To all Lamborghini Dealers and Authorised Service Points
From After Sales Service
Pages 1+2
Object Technical Bulletin ref.:CT.03.04
Service 2500 km (Coupon A) or 12000 km-
Lamborghini Gallardo L140
Group 140.00.00.00.04.AditionalCheck.GB
Date 31.05.2004

Aiming to keep high the quality standards of vehicles, be informed that we have recently introduced a new operation in the 2500 km free service checklist.

Picture (d)

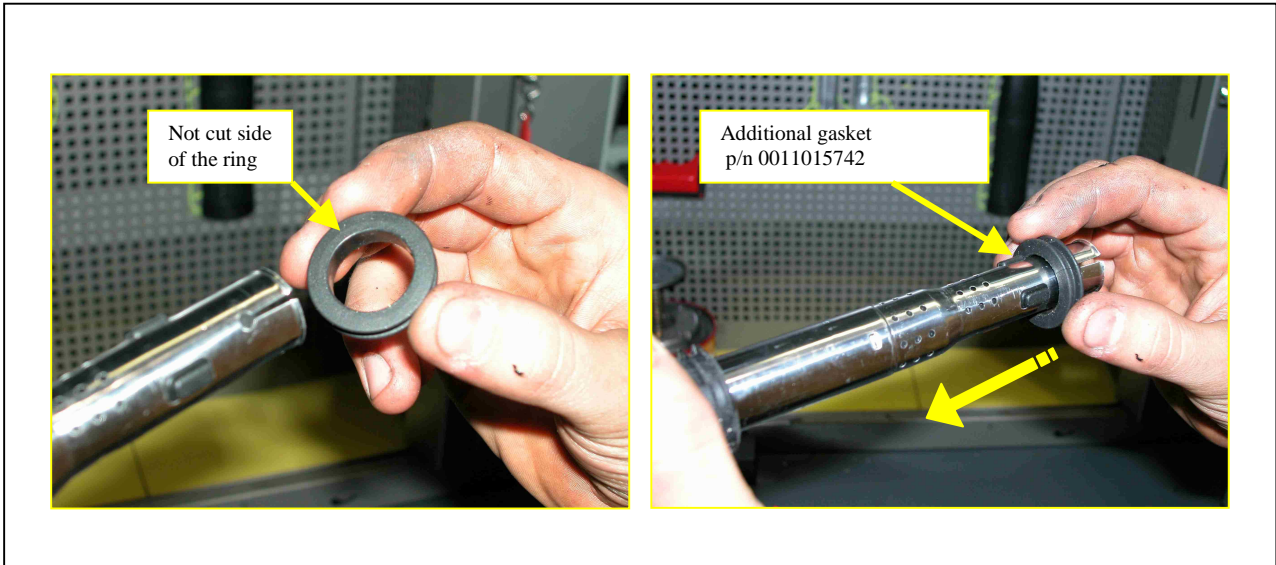
ATTENTION: The correct ignition coil fitting can be verified by checking the measure as shown in picture d.

X = 25,5 mm
+/- 1,5 mm

Picture (a)

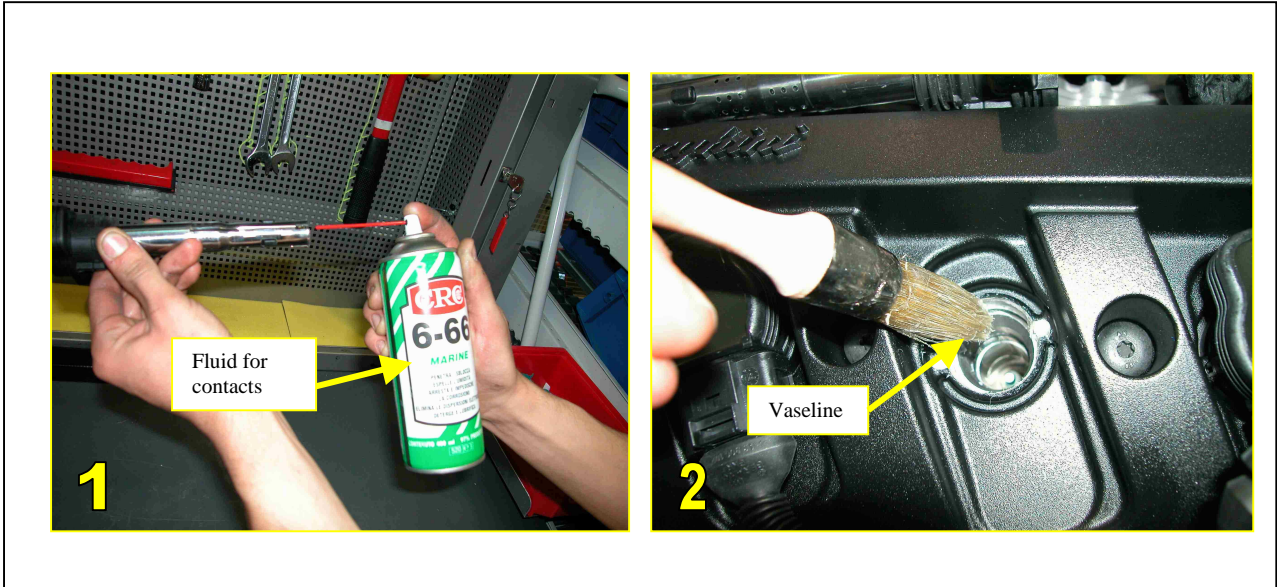
1. Remove the ignition coil
2. Check that ignition coil is in good order (and not supplied with an additional ring)
3. Fit the additional gasket p/n 0011015742 as shown on picture (a)
4. The gasket has a cut surface, this side must be downfaced towards the coil (see note on picture a)
5. Push the gasket, making sure it is perfectly close-fit (figure a)
6. Spray the special fluid for the cleaning of electrical contacts as shown in picture (b-1). We suggest you to use CRC 6-66 Lamborghini code 008970129.
7. Lubricate with vaseline the ignition coil housing (figure b-2)
8. Reassemble the ignition coil making sure it is properly fit in its housing as shown in picture c-1 and c-2.
